PRODUCT SUPPORT BULLETIN # 305

23-66-1666, 23-66-2121, 23-66-2145 SWITCH

SUBJECT: LEAD WIRE REMOVAL

Switch Bottom

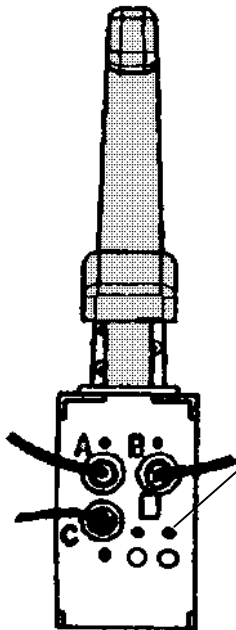
AS A PRODUCT IMPROVEMENT THE 23-66-1666, 23-66-2121, & 23-66-2145 SWITCH ARE SEALED AGAINST CONTAMINATION.

THERE ARE FIVE (5) HOLES IN THE BOTTOM OF THE 23-66-1666, 23-66-2121 & 23-66-2145 SWITCH TO RECEIVE LEAD WIRES.

NEXT TO THESE HOLE ARE 5 SMALLER HOLES THAT HAVE A BOTTOM OR THIN PLASTIC 'WINDOW' IN THEM

TO REMOVE THE LEAD WIRES FROM THE SWITCH, IT IS NECESSARY TO BREAK THROUGH THE THIN PLASTIC 'WINDOWS' OF THESE SMALL HOLES, TO ALLOW YOU TO INSERT A PROBE TO RELEASE THE WIRE(S).

AFTER REPLACING OR REINSERTING LEAD WIRES INTO THE SWITCH, THE SMALL 'WINDOW' HOLES THAT WERE BROKEN TO INSERT THE PROBE, MUST BE COVERED WITH 'RTV' SILICONE ADHESIVE/SEALANT (P/N 44-22-0070 - 2.8 FLUID OZ TUBE) TO PREVENT UNNECESSARY CONTAMINATION FROM REACHING THE INTERNAL COMPONENTS OF THE SWITCH AND EARLY SWITCH FAILURE.
